PCN# 20230515000.1A

**Qualification of new BOM for select package Devices
Change Notification / Sample Request**

Date: July 13, 2023
To: PREMIER FARNELL PCN

Sample product shipping label (not actual product label)

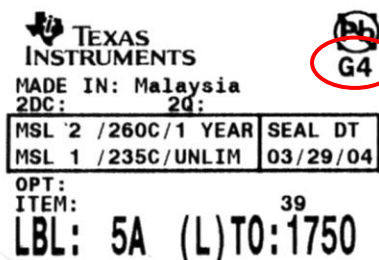
Changes to product identification resulting from this PCN:

G4 = NiPdAu
G3 = Matte Sn
